Amendments to the Drawings:

Applic. No. 10/539,837
Response Dated July 29, 2008
Responsive to Office Action of April 29, 2008

Applic. No. 10/539,837
Reply to Office Action dated 04/29/2008
Amendment dated 07/29/2008
Annotated Sheet

FIG. 7

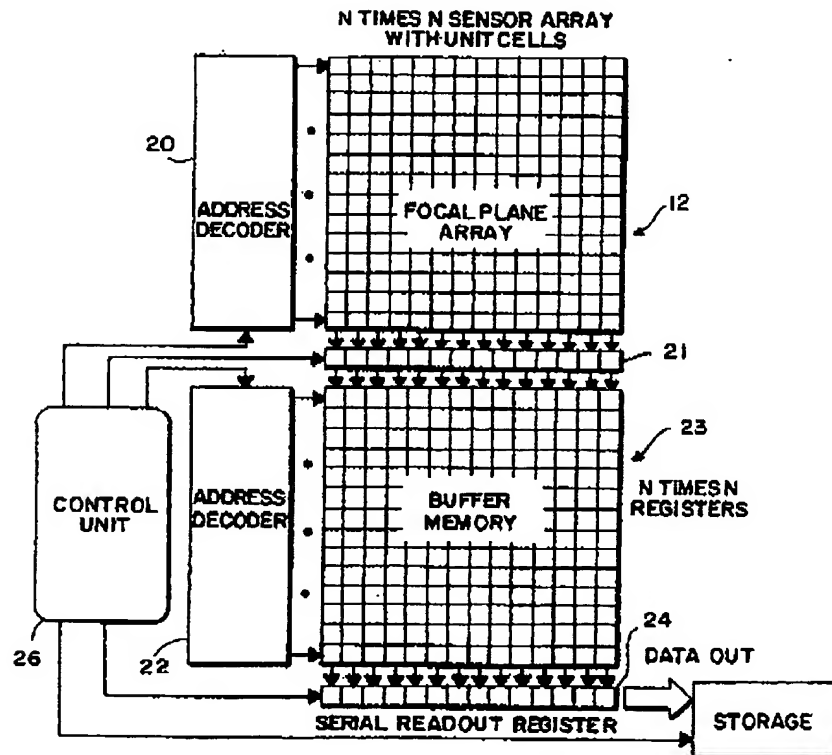
As can be seen, the Office Action did not, separately, point out where in the references Applicants' particularly claimed data processing unit, internal to each readout cell, could be found. Rather, item 10 of the Office Action referred back to the rejection of Applicants' former claim 1. Page 7 of the Office Action points to the "control unit" of Fig. 7 of FOSSUM1, as allegedly showing the claimed "data processing

means" of Applicants' former claim 1. However, as can be seen, more particularly, from Fig. 7 of FOSSUM1, the control unit (26 of Fig. 7 of FOSSUM1) is not internal to each readout unit cell, but instead, is external to the entire buffer memory. Fig. 7 of FOSSUM1, illustrating the control unit 26 being external to all of the readout cells, is reproduced herebelow, for convenience.

FIG.3

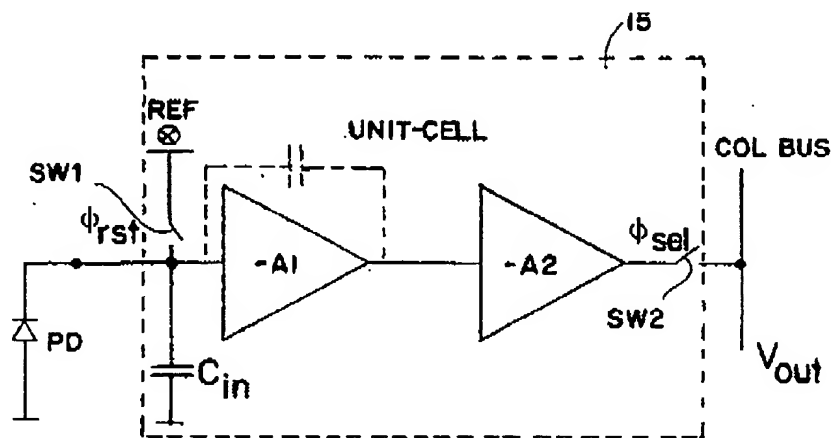
Fig. 3 of FOSSUM1 shows a basic schematic diagram of a "unit cell" for one photodetector diode of the solid state array which is connected between a photovoltaic type of

photodetector diode and a column bus for readout. As can be seen from FIG. 3 of FOSSUM1, the "unit cell" 15 of Fig. 3 of FOSSUM1 does not include an internal data processing unit. Fig. 3 of FOSSUM1 is additionally being reproduced herebelow, for convenience.

See also, for example, col. 6 of FOSSUM1, line 50 - col. 7, line 62, describing the unit cell of Fig. 3 of FOSSUM1. Thus, among other limitations of Applicants' claims, the FOSSUM1 reference fails to teach or suggest each readout cell including an internal data processing unit, as required by Applicants' claim 44. The MOULSLEY and GRUSS references, cited in item 10 of the Office Action in combination with FOSSUM1 against Applicants' former claim 19 (current claim 44), do not cure the above discussed deficiencies of the FOSSUM1 reference.

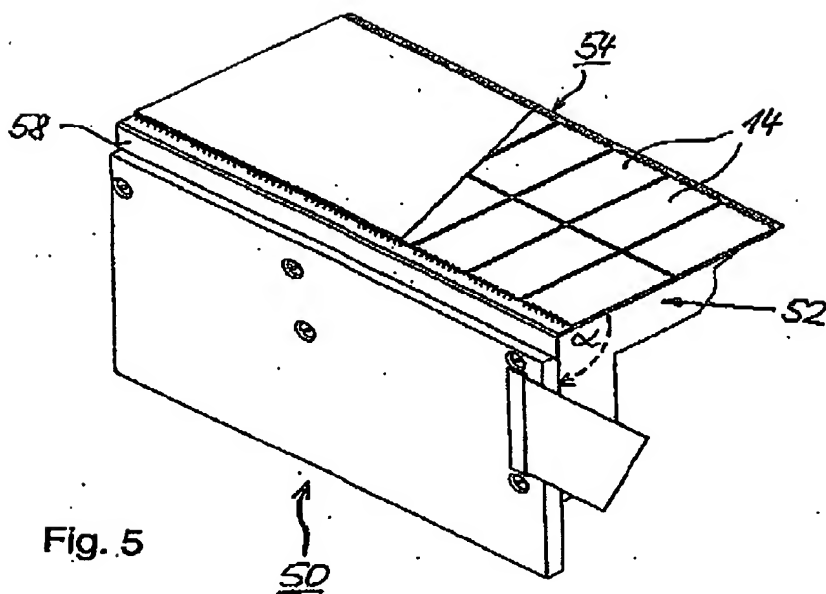
Additionally, in Fig. 4, the word "TRESHOLD" was changed to "THRESHOLD" and the phrase "GLOBAL TRESH" was changed to "GLOBAL THRESH". In Fig. 8A, " V_{THRES} " was changed to " V_{THRESH} ".
